Agenda for 79th PCCM

North Eastern Regional Power Committee

79th Protection Coordination Sub-Committee Meeting

Date: 19/05/2025 (Monday)

B.8 Grid Disturbance in Tuirial HEP of NEEPCO & Kolasib and Bairabi areas of Mizoram Power System on 07-04-2025:

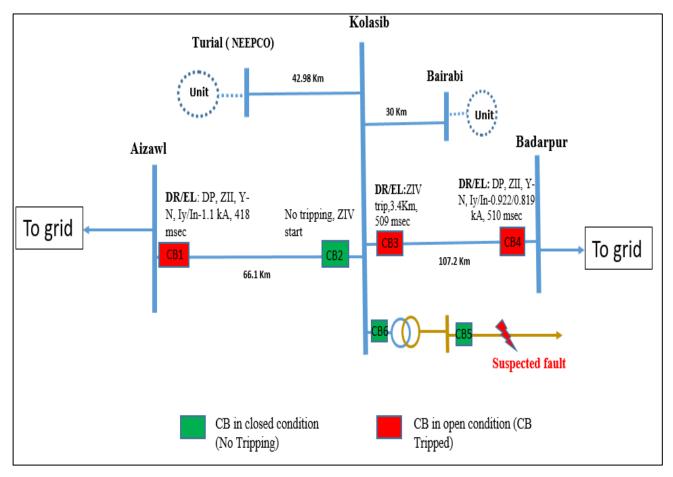
As per DR analysis, Y-N fault with Iy-922 A, In-819 A initiated at 03:34:05.236 Hrs which was cleared within 510 msec from Badarpur end on operation of DP, ZII (ZIII start) and within 509 msec on ZIV trip from Kolasib end. For 132 kV Aizawl-Kolasib line, fault cleared within 418 msec from Aizawl end on DP, ZII (ZIII start). DR of different time submitted at Kolasib end. There was no tripping from Kolasib end (ZIV start as per EL)

Fault is suspected fault in downstream of Kolasib S/S as ZIV operated from Kolasib end (Fault distance-3.4 Km as per EL).

- Protection system of downstream feeder and HV side transformer failed to isolate the fault due to which fault was cleared by tripping of healthy 132 kV Aizawl-Kolasib & 132 kV Badarpur-Kolasib lines. P&ED Mizoram needs to ensure healthiness of protection system of 132 kV Kolasib-Tuirial line.
- DR time drift of 5 min observed at Kolasib end for 132 kV Badarpur Line & 2 min for 132 kV Aizawl line.
- Non-submission of Flash report and detailed report by P&ED Mizoram & NEEPCO which is a violation of Clause 37.2 (b) & 37.2 (e) of IEGC regulation 2023.

P&ED Mizoram to share the root cause of the event and update the actions taken on the above-mentioned issues.

Event 2: At 18:15 Hrs of 24th April'25

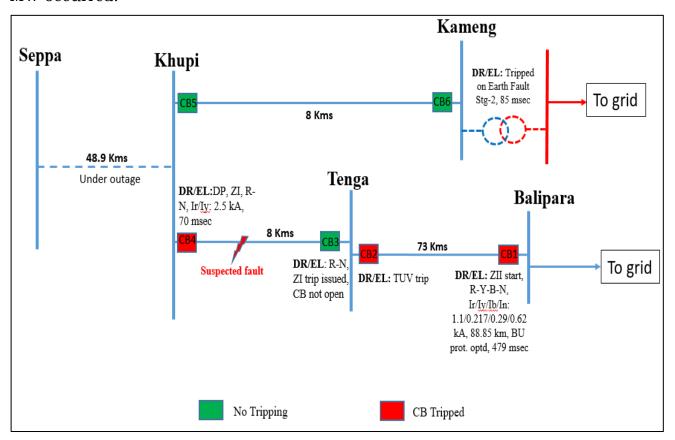
As per DR analysis, R-N fault (Ir-2.5 kA, In-2.5 kA) initiated at 18:15:35.763 Hrs in 132 kV Tenga-Khupi Line which was cleared within 70 msec from Khupi end on operation of DP, ZI. From Tenga end, DEF start & ZI trip command issued. However, Tenga CB did not open.

Due to non-opening of CB at Tenga, fault was continuously feeding through 132 kV Balipara-Tenga line which was cleared by tripping of Balipara CB within 479 msec on operation of BU E/F O/C (Z2 started).

At 18:15:49.699 Hrs, Kameng ICT tripped on E/F Stg-II within 85 msec which seems to be unwanted.

Non-opening of CB at Tenga end for 132 kV Khupi Line despite issuance of ZI trip is a matter of concern. The same needs to be checked by DoP Arunachal Pradesh.

- Instantaneous tripping of Kameng ICT on E/F Stg-II during fault in downstream lines is unwanted. Maloperation of the ICT HV side protection is likely due to very low current pick up settings for High set B/U E/F protection. High set Backup E/F setting needs to be reviewed and coordinated to prevent unwanted tripping for the fault beyond protected zone.
- DR analog and digital channel of Kameng ICT needs to be standardized as per recommendations in FOLD working group.
- The back-up protection settings at Kameng, Khupi and Tenga needs to be reviewed and coordinated as per NER protection philosophy.
- Non-submission of flash report and detailed report by DoP Arunachal Pradesh
 & NEEPCO which is a violation of Clause 37.2 (b) & 37.2 (e) of IEGC regulation
 2023.

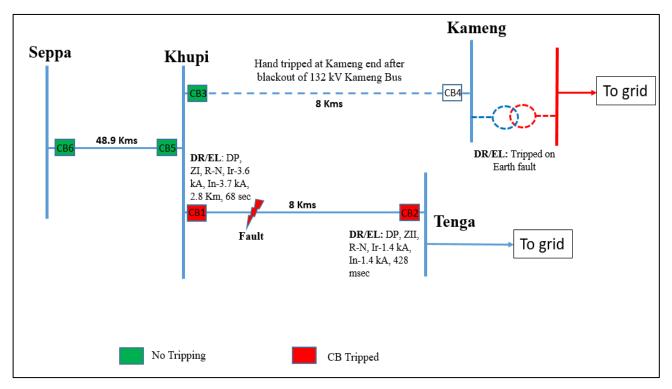
Further, he informed that there is no distance protection at the Umiam stg I end for the Umiam line and also there are no LDP for the lines due to non-availability of the OPGW links.

Forum suggested MePGCL that High set to be disabled at Umiam St I.

2.2. DR Snapshot of Kameng for 400/132 kV Kameng ICT

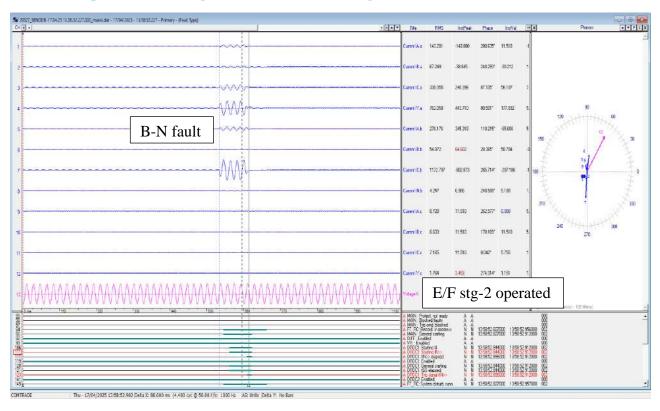
At 13:58:52.814 Hrs, Kameng ICT tripped on E/F Stg-II within 88 msec which seems to be unwanted.

- Instantaneous tripping of Kameng ICT on E/F Stg-II during fault in downstream lines is unwanted. Maloperation of the ICT HV side protection is likely due to very low current pick up settings for High set B/U E/F protection. High set Backup E/F setting needs to be reviewed and coordinated to prevent unwanted tripping for the fault beyond protected zone.
- DR analog and digital channel of Kameng ICT & 132 kV Khupi-Seppa Line needs to be standardized as per recommendations in FOLD working group.
- Non-submission of flash report and detailed report by DoP Arunachal Pradesh & NEEPCO which is a violation of Clause 37.2 (b) & 37.2 (e) of IEGC regulation 2023.
